IEEE 802.3 Ethernet Working Group
DRAFT Liaison Communication

Subject: Reply to Incoming Liaison JTC 1/SC 25/3073/INF

We would like to thank you for the preview of JTC1-SC25/3068/CD, ISO/IEC 11801-1/AMD1 ED1. The IEEE 802.3 Working Group (the WG) has some comments on the draft:

PSANEXT SPEC

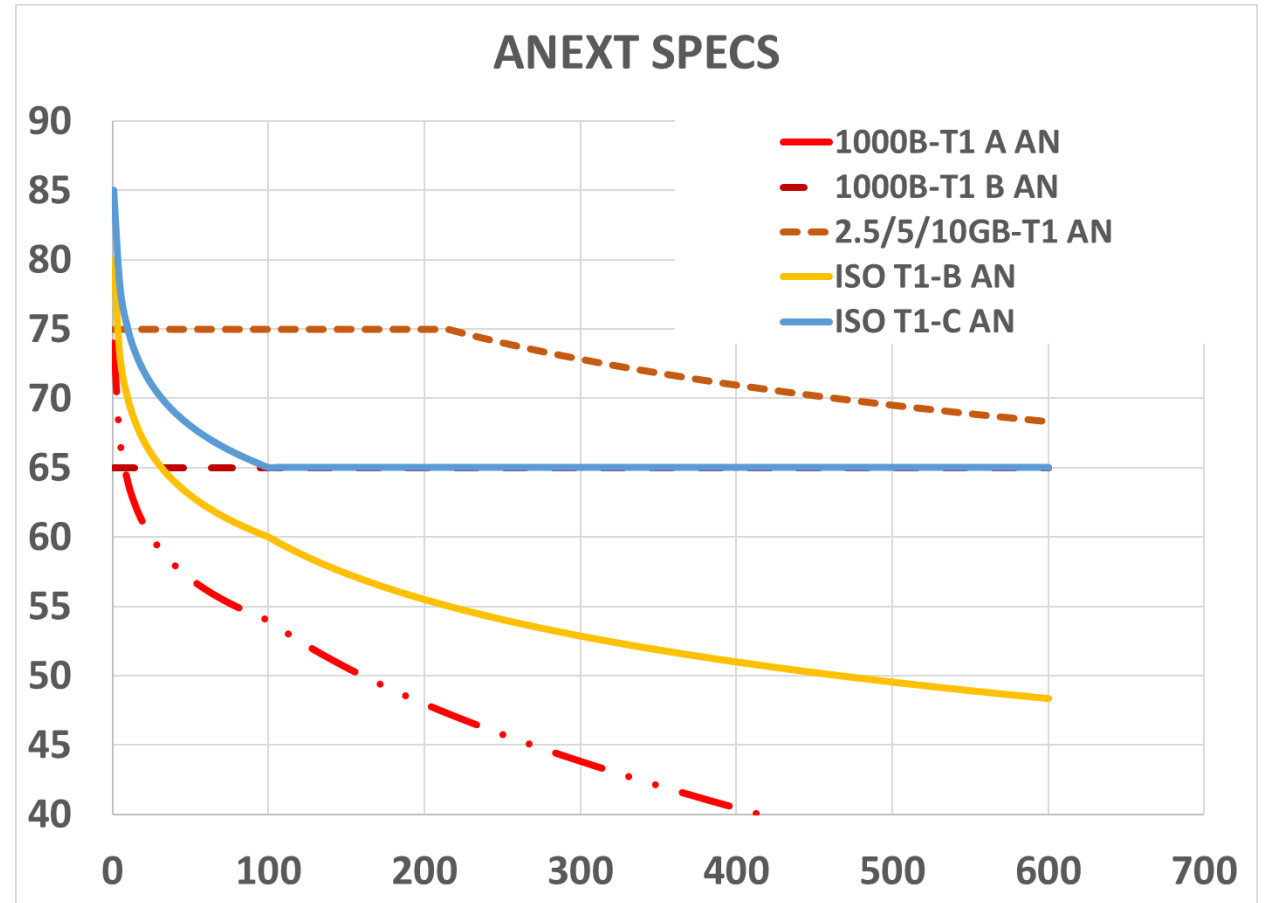
- T1-B ANEXT:
 - Meets 1000BASE-T1 seg A
 - Fails 1000BASE-T1 seg B, 2.5/5/10GBASE-T1
- T1-C ANEXT
 - Meets 1000BASE-T1 seg A, B
 - But is excessive on frequency
 - Fails 2.5/5/10GBASE-T1

PSAACR-F SPEC

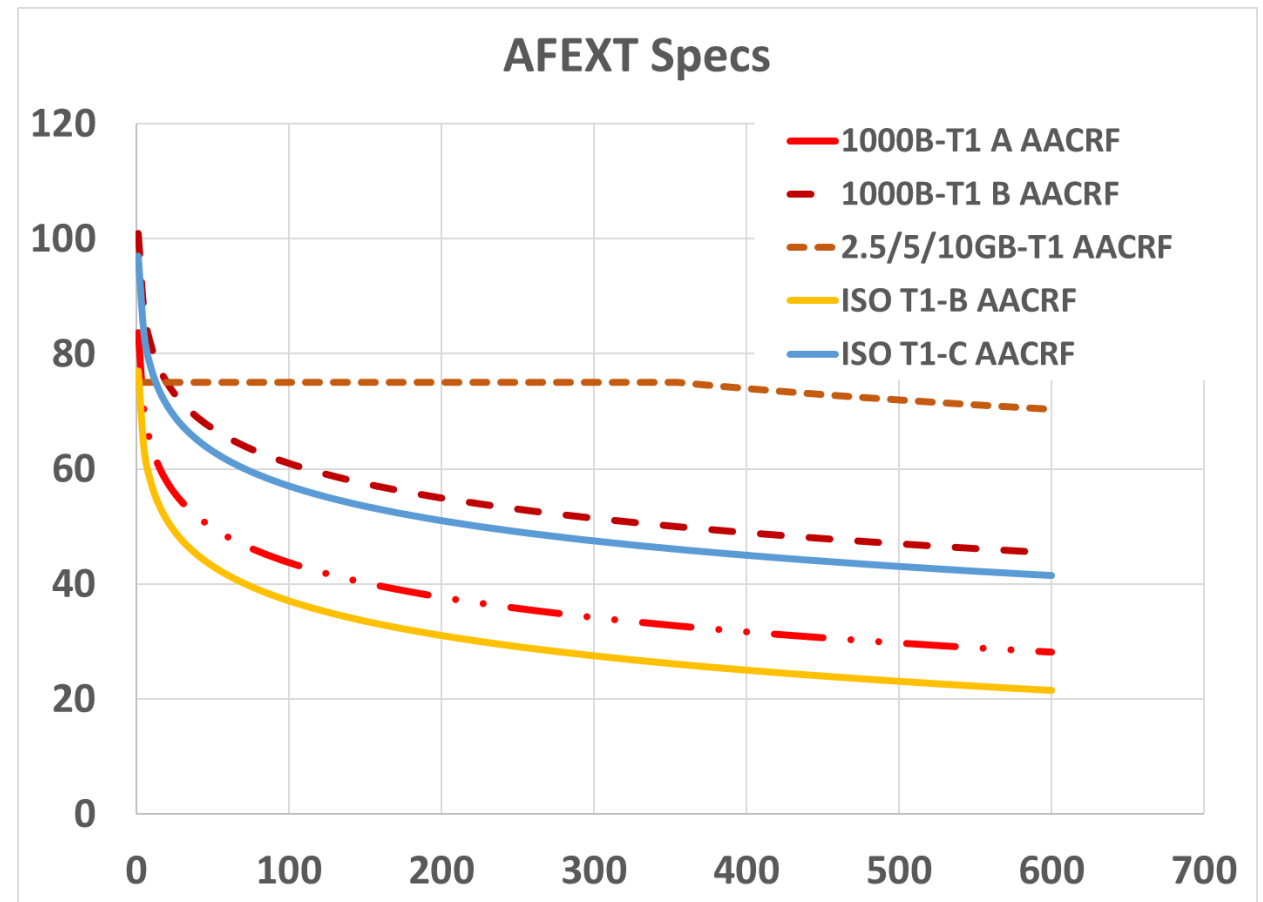
- T1-B PSAACR-F:
 - Fails 1000BASE-T1 seg A
 - Fails 1000BASE-T1 seg B, 2.5/5/10GBASE-T1
- T1-C PSAACR-F:
 - Meets 1000BASE-T1 seg A
 - But is excessive on frequency
 - Fails 1000BASE-T1 seg B, 2.5/5/10GBASE-T1

Note: neither specification defines length scaling for this parameter, so none is applied.

- ISO T1-B has frequency range fitting 1000BASE-T1 applications, but has insufficient PSAACR-F specifications
 - Noting that T1-B PSAACR-F is marked ffs, recommend aligning to meet 1000BASE-T1 link segment A specifications (Eqn 97-24 in IEEE P802.3dc D3.0)
